METROPOLITAN GOVERNMENT OF NASHVILLE AND DAVIDSON COUNTY

STAFF RECOMMENDATION 209 South 5th Street April 18, 2018

Application: New construction—infill; Partial demolition; Alteration
District: Edgefield Historic Preservation Zoning Overlay
Council District: 06
Map and Parcel Number: 08215021100
Applicant: Dave Wachtel
Project Lead: Melissa Baldock, melissa.baldock@nashville.gov

Figure 4. The greenhouse structure was constructed on top of the side addition prior to 1995.

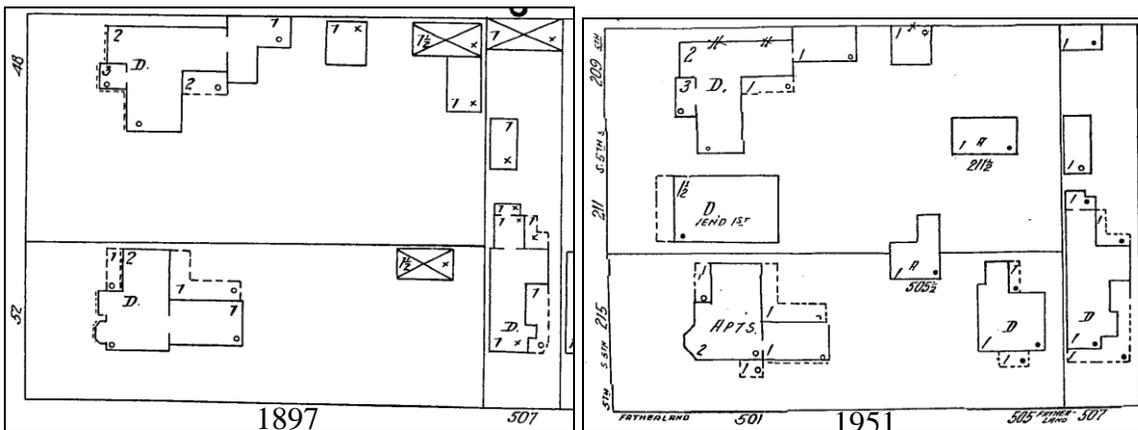
Demolition: The applicant intends to remove the glass greenhouse-type structure above the one story side addition (See Figure 4). This greenhouse structure is not historic, as it was constructed in the late 1980s or early 1990s. Staff finds that its removal will improve the historic character of the house. Staff therefore finds that the removal of the greenhouse structure meets Section V.B.2 for appropriate demolition and does not meet section V.B.1 for inappropriate demolition.

1 PRELIMINARY FLOOR PLAN OF NEW BALLROOM WITH UPPER ROOM AND DECK

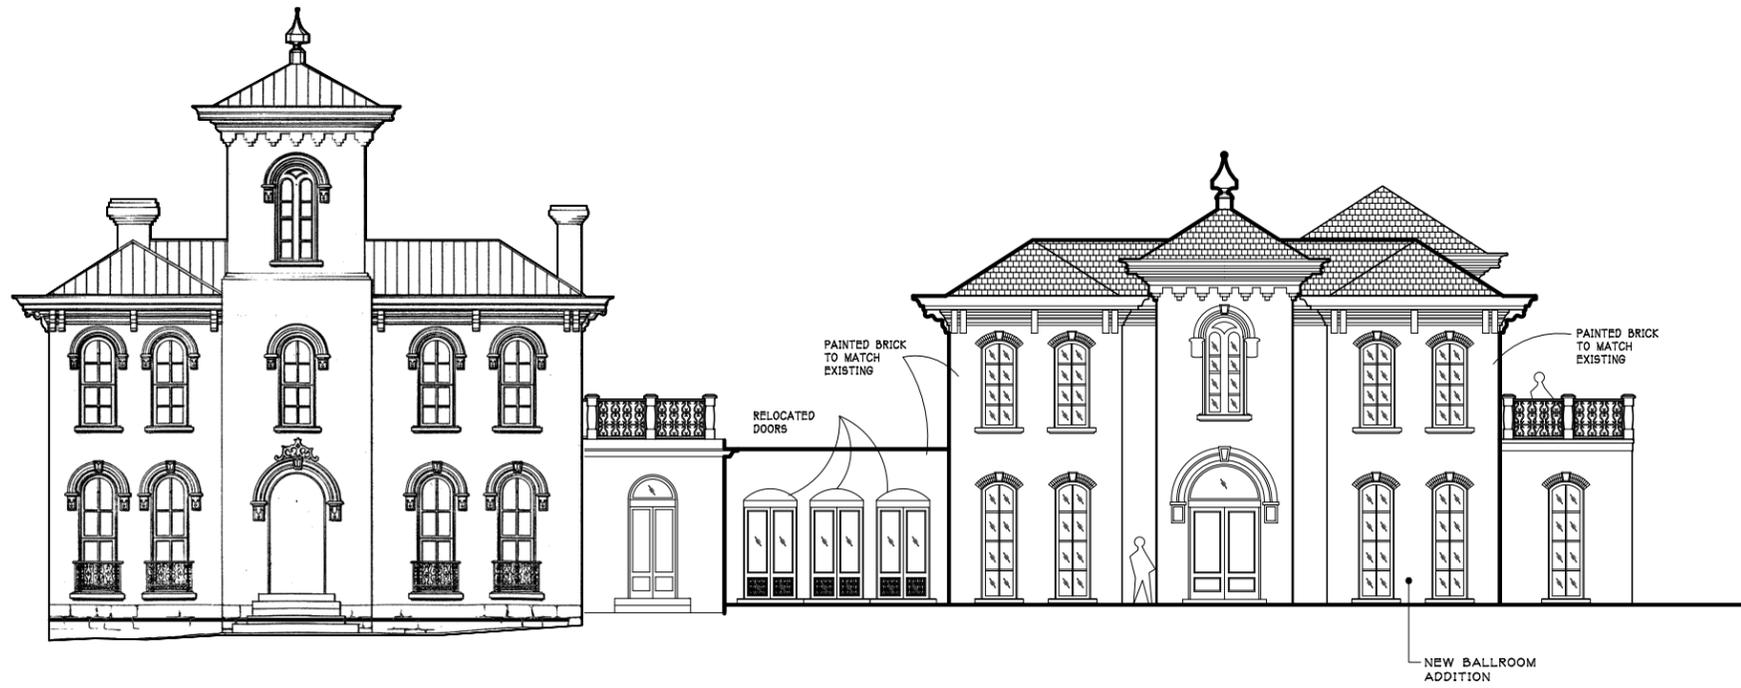
The one-story connector is set back from the front walls of the two structures by a minimum of eighteen feet (18'), and it will be largely open in nature, with three sets of French doors that take up the majority of the facade. Staff finds that the design and scale of the connector will reduce its impact on the historic site and is appropriate because of the peculiarities of this lot.

The main two-story portion of the infill has a width of forty-eight feet (48'). This is comparable to the width of the historic house, which is approximately forty-six feet, six inches (46'6") wide. A one-story extension is set back eleven feet (11') from the front wall of the infill and is twelve feet (12') wide. The width of the one-story extension is similar to that of the one-story extension to the historic house, which was approved by MHZC in 1978. Staff finds this width to be appropriate. However, staff finds that the railing on top of this extension and the rooftop patio is not appropriate. The area of the

one-story extension contains a stairway, and because there is no roof to this stairway, it is not fully enclosed, as typically required. As opened stairwells leading to balconies are not found in the Edgefield neighborhood, staff finds that this configuration is not appropriate. Staff recommends that the railing be removed and this portion of the infill be fully enclosed.

The connector will be one-story in height and will match that of the existing, one-story addition approved by MHZC c. 1978. It will be thirteen feet (13') tall, twenty-feet (20') wide, and nineteen feet (19') deep. Staff finds the height and scale of the connector to be appropriate.

4. The railing on top of the infill's one-story addition be removed and this portion of the infill be fully enclosed;
5. The finial on top of the infill be removed;
6. Staff approve a brick sample;
7. Staff approve the materials of all trim and details;
8. Staff approve the roof material and color;
9. Staff approve the final details, dimensions and materials of windows and doors prior to purchase and installation;
10. Staff approve the material and design of all railings and gates; and,
11. MHZC approve the location of any new HVAC or other utilities;

3 5TH STREET ELEVATION 0 4' 8' 16'

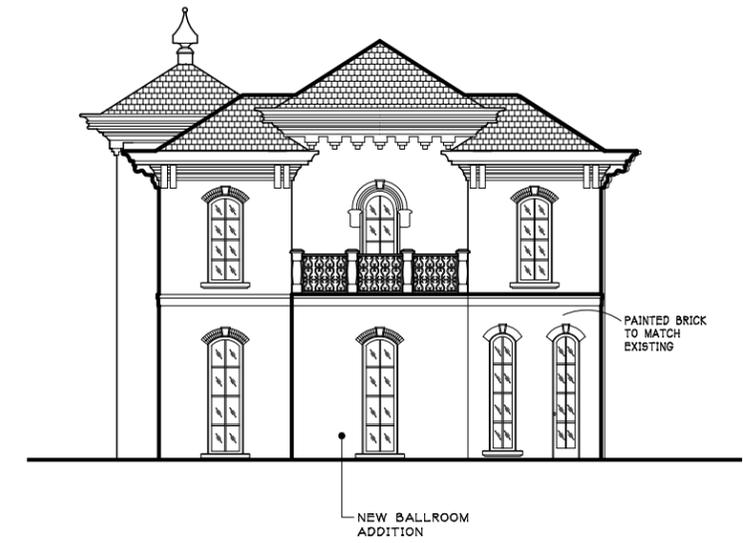
The new infill is oriented towards South 5th Street, which is appropriate. A new gate will be cut into the existing brick wall to provide pedestrian access from the sidewalk. Staff recommends inclusion of a walkway from the sidewalk to the gate and front entry. Staff further recommends that the gate be largely open in design so as to be appropriately oriented to the street.

Height & Scale: The proposed infill is two stories, with an eave height of approximately twenty-six feet (26') and a maximum ridge height of approximately thirty-seven feet (37'). The primary ridge height will be thirty-two feet (32'). Staff finds these heights to be appropriate because they are similar to the heights of the historic house to which it is connected. The new infill's eave height and primary ridge height will match those of the historic house next to it, and its maximum height will be lower than that of the historic house. Staff recommends that finial be removed from the top of the central tower of the infill, as it increases the height of the infill at the front and is not a common feature found in the historic district.

With the conditions that the finial be removed, the railing on the one-story extension be removed, and the extension be fully enclosed, staff finds that the infill meets Sections III.B.2.b. and III.B.2.c. of the design guidelines.
